DATE: 03/17/25
TO: All Bidders
FROM: David Cienfuegos, Purchasing Specialist
SUBJECT: Addendum 1 – Bid 706 Moorpark College Maker’s Space HVAC Project

Attached to this addendum please find attachments M1 & M2 Addendum 1

APPLIED ART BUILDING COOLING TOWER REPLACEMENT
NOTES AND SCHEDULE

SHEET NO. M2 OF 4

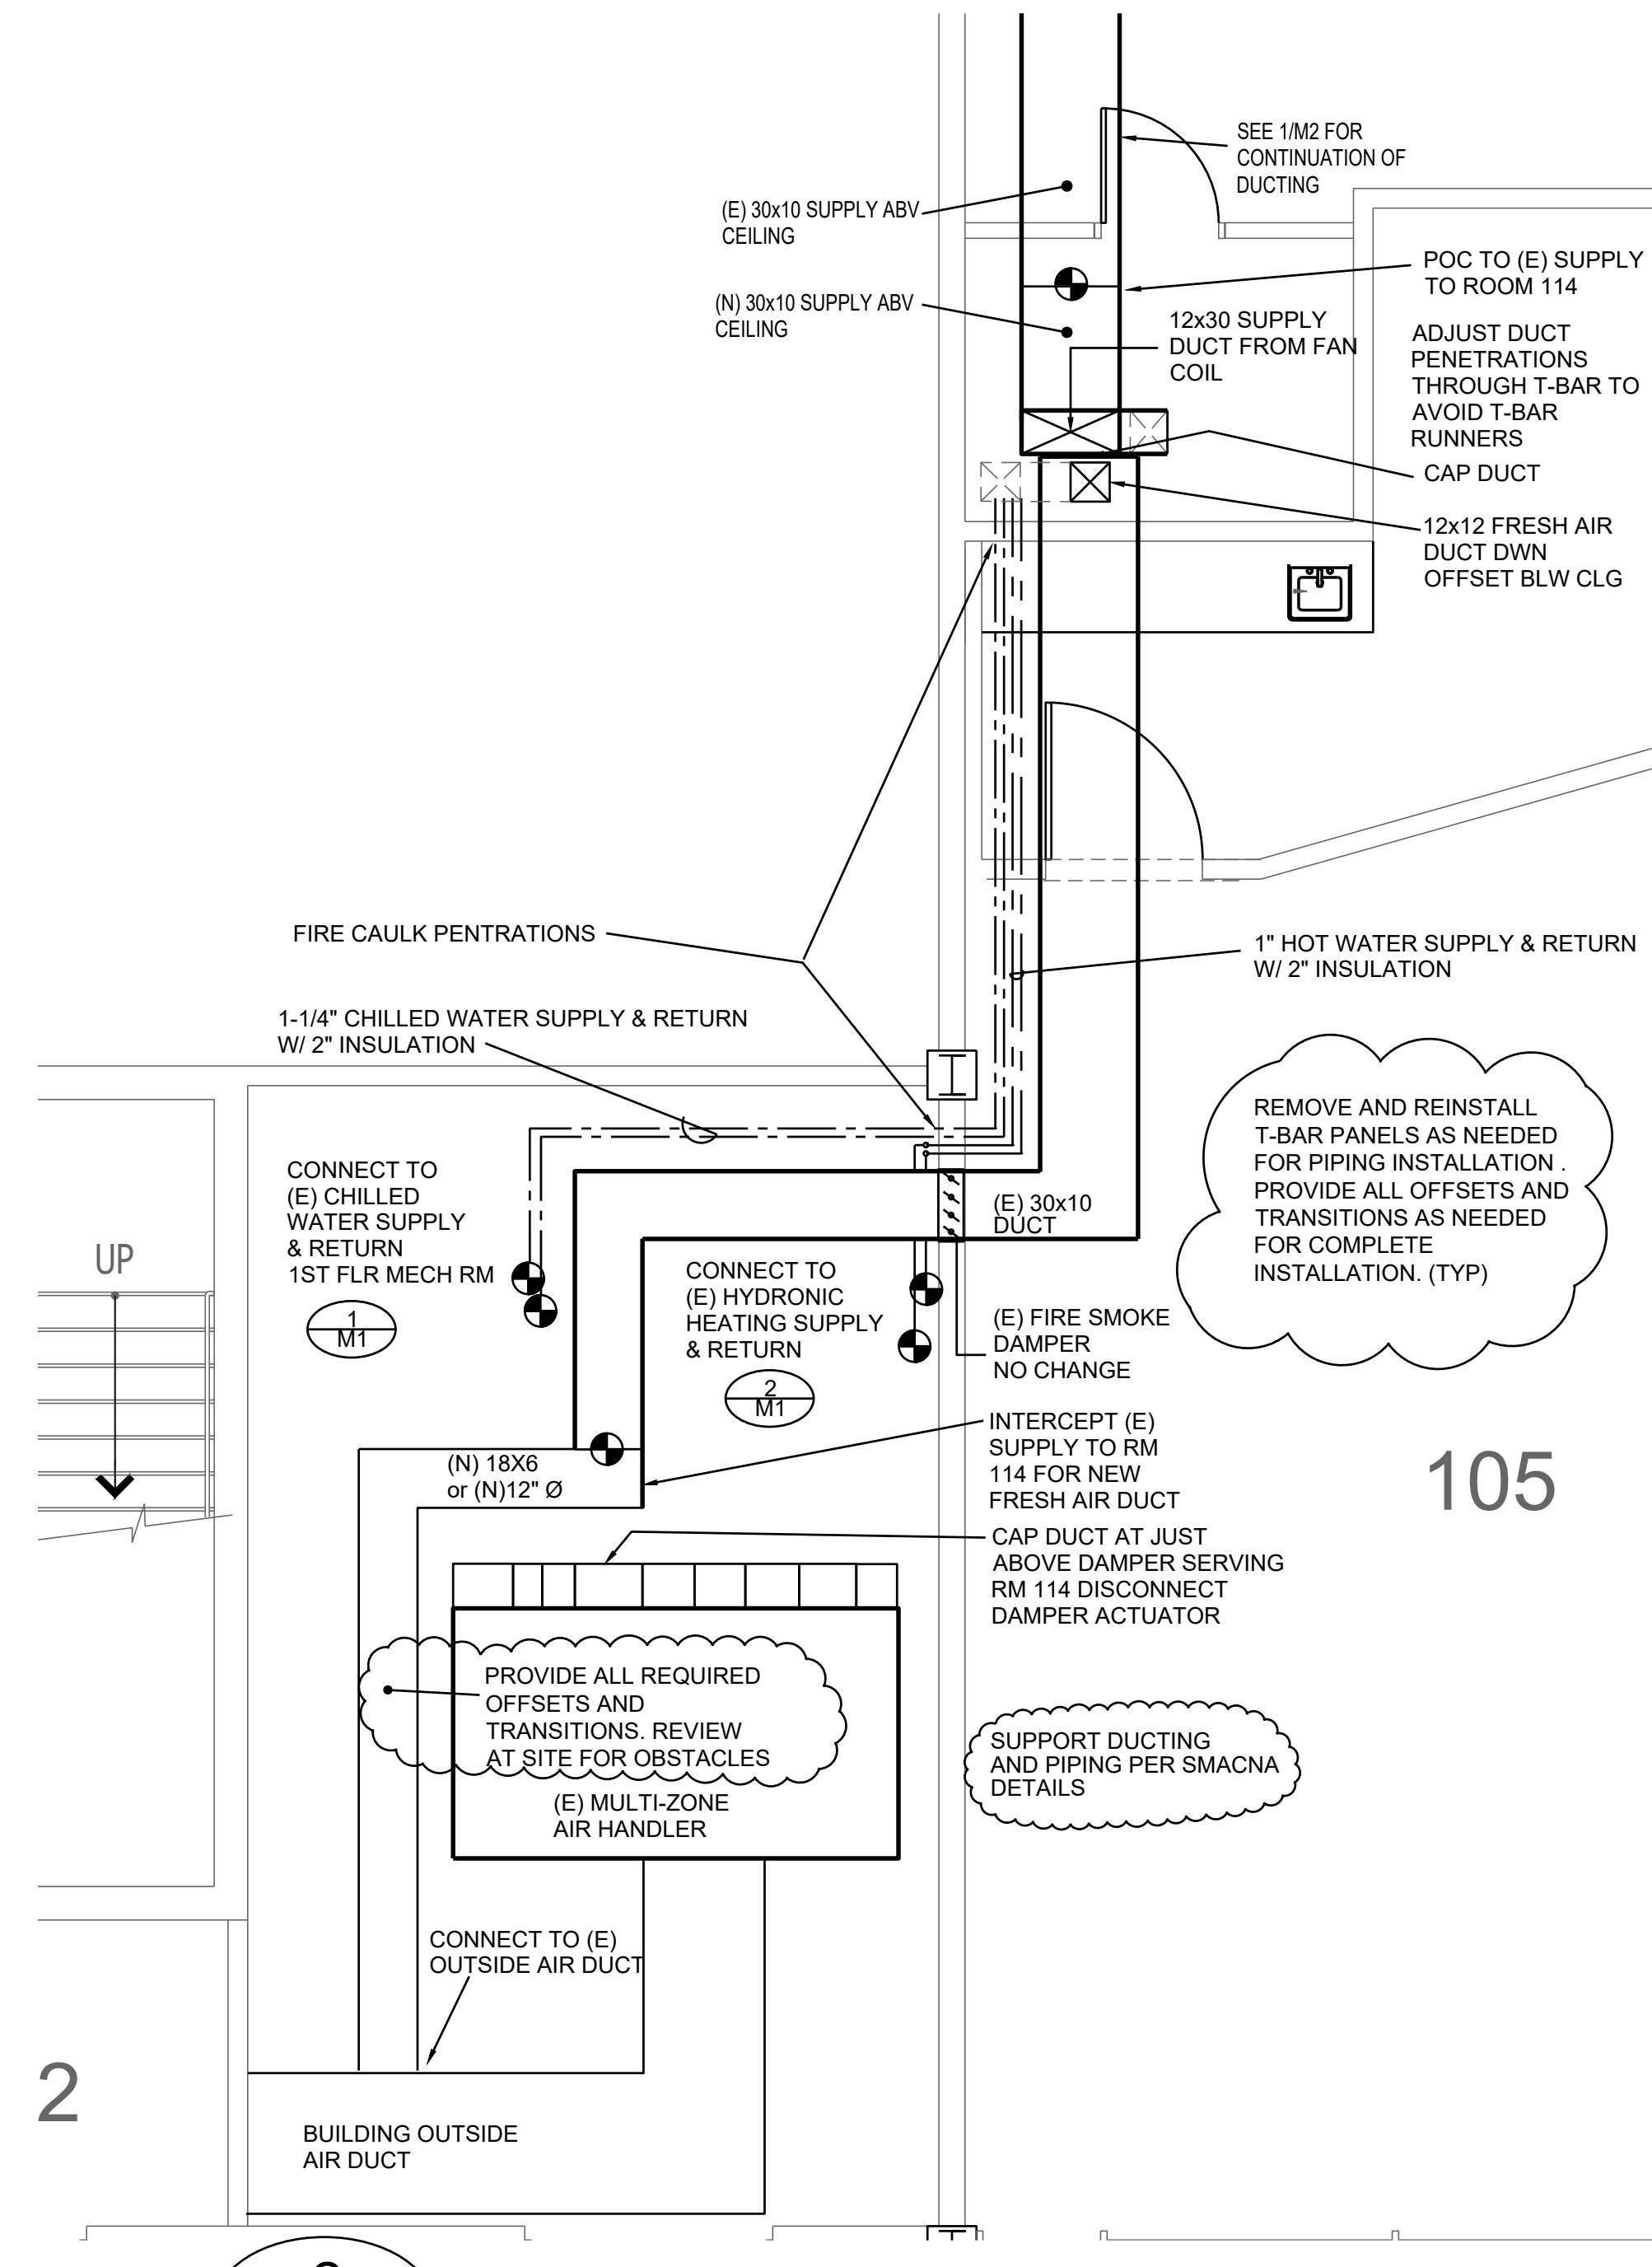
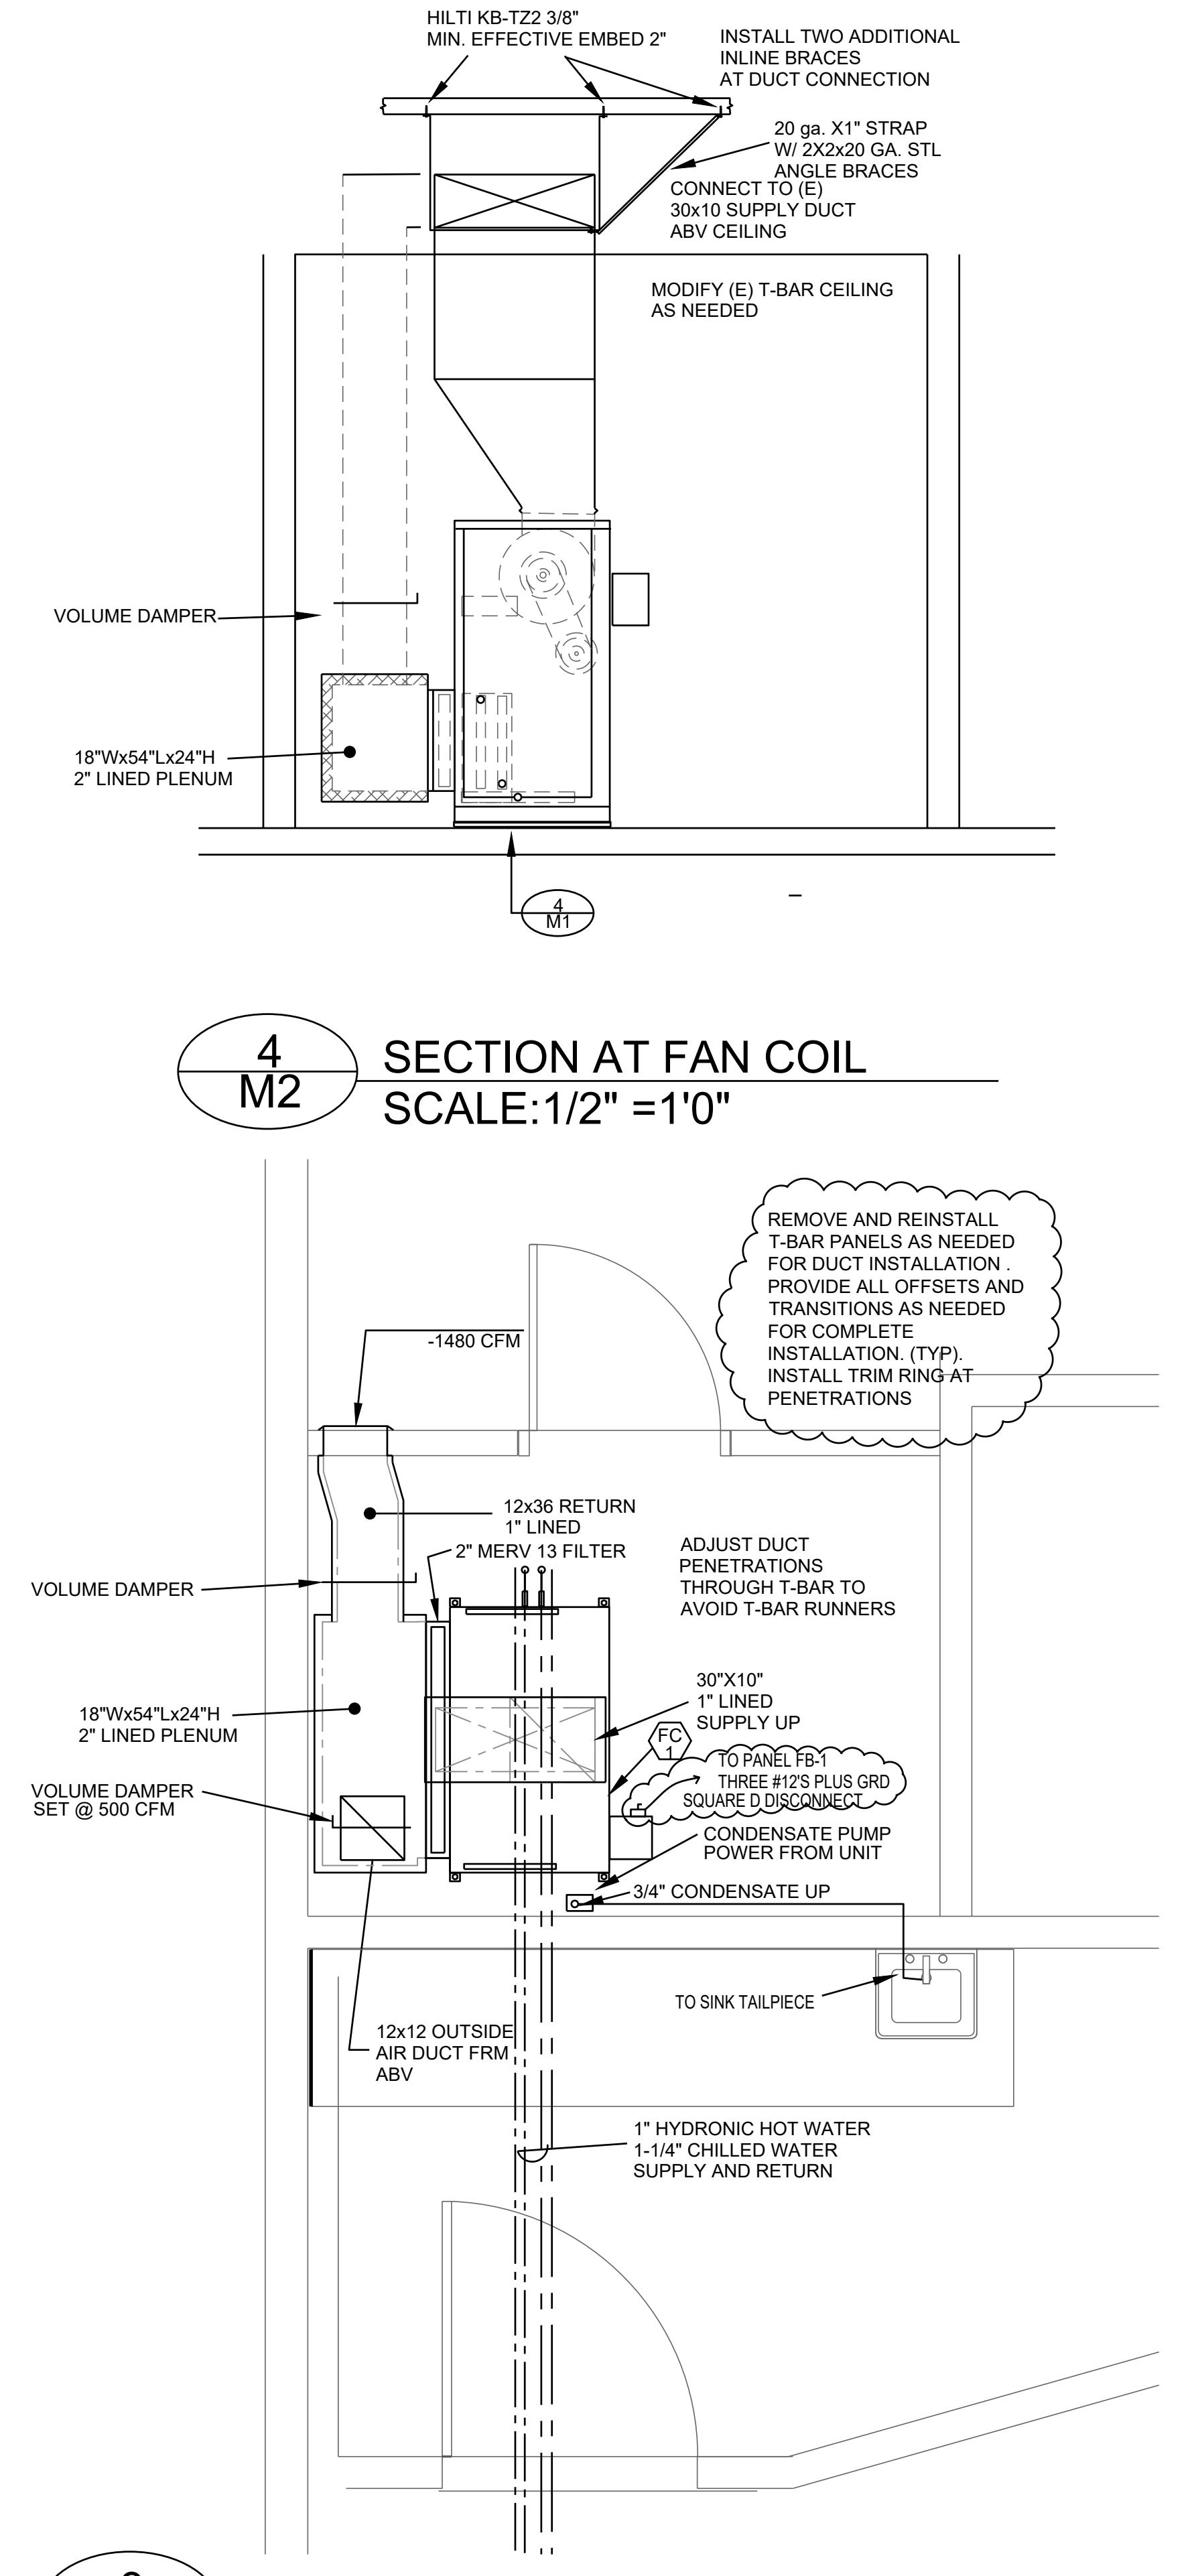
1. Power to fan coil to be in 1 or 3 phase?
 - a. Single 208/1/60. Provide electrical power to new fan coil from Panel FB in Maker’s Space per attached plans. Provide new 208/1/60 15 amp breaker, wire, and conduit, connections, labels, two pole disconnect at unit. Provide power to condensate pump and Control panel from fan coil power. Install per California Electrical Code Requirements. See M2 Addendum 1 for panel location in Maker’s Room.
2. What are the hours of work?
 - a. Check Special Conditions.

4. Are the back walls of the room the fan is to be installed fire rated walls?
 - a. Yes. Please see attached plan for fire rated walls that will require fire caulking. Fire Caulking - Hilti FS-1 Max is an acceptable product.
